Access Compliance Report

Public Rights-of-Way

Intersection ID: 42582	Main Street: N_CHURCH_ST	Cross Street: N_TRYON_ST	Location: SW
ADA ID: 831C3BDB4A36	Ramp Type: Para	Initial Pass/Fail: Fail	Overall Compliance: No
		Severity Score: 12.5

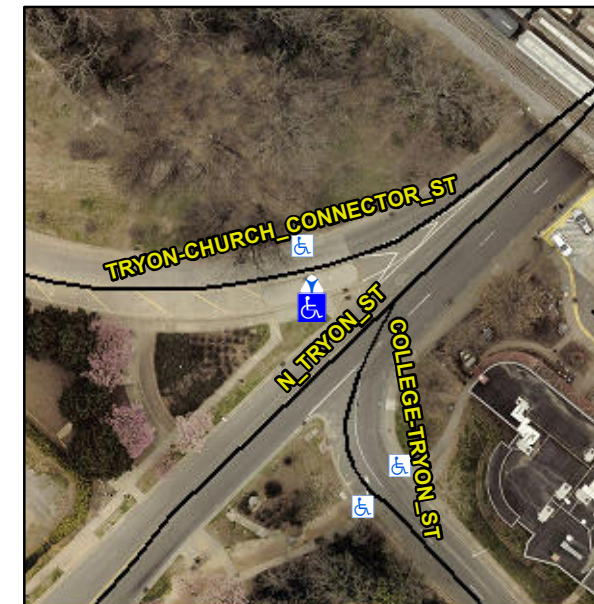
NO LT RAMP

Compliance	Description	Data	Compliance	Description	Data
N/A	Ramp Length LT (in)	N/A	N/A	Ramp Length RT (in)	237.0
N/A	Ramp Width LT (in)	N/A	Yes	Ramp Width RT (in)	59.0
N/A	Ramp Slope LT (%)	N/A	Yes	Ramp Slope RT (%)	8.6
N/A	Ramp XSlope LT (%)	N/A	Yes	Ramp XSlope RT (%)	1.8
N/A	Landing Length (in)	N/A	N/A	DWS Provided?	N/A
N/A	Landing Width (in)	N/A	N/A	DWS Contrast?	N/A
N/A	Landing Slope (%)	N/A	N/A	DWS Length (in)	N/A
N/A	Landing X Slope (%)	N/A	N/A	DWS Full Width?	N/A
N/A	Landing Curb? (Y/N)	N/A	N/A	DWS Offset (in)	N/A
N/A	Shared Landing?	N/A			
N/A	Gutter Ponding?	N/A	N/A	Gutter Slope (%)	N/A
N/A	Gutter Lip Ht (in)	N/A	N/A	Gutter X Slope (%)	N/A
N/A	Painted X Walk1?	Yes	N/A	Painted X Walk2?	N/A
	X Walk 1 Direction	To NW		X Walk 2 Direction	N/A
N/A	X Walk 1 Width (in)	96.0	N/A	X Walk 2 Width (in)	N/A
	X Walk 1 Slope (%)	6.7		X Walk 2 Slope (%)	N/A
	X Walk 1 X Slope (%)	5.1		X Walk 2 X Slope (%)	N/A
N/A	Ramp inside XWalk1?	Yes	N/A	Ramp inside XWalk2?	N/A

Road Slope (%)	N/A	N/A	Clear Space?	N/A
	Road X Slope (%)	N/A	N/A	Clear Space to XWalk (in)	N/A
N/A	Any Obstructions?	N/A	N/A	Storm Grate/Utility Hazard?	N/A
	Obstruction Type			Storm Grate/Utility Type	
		N/A			N/A
			Yes	Surface Condition? (G/P)	Good
			N/A	Curb Slope (%)	21.0

Remove & Replace Entire Ramp.
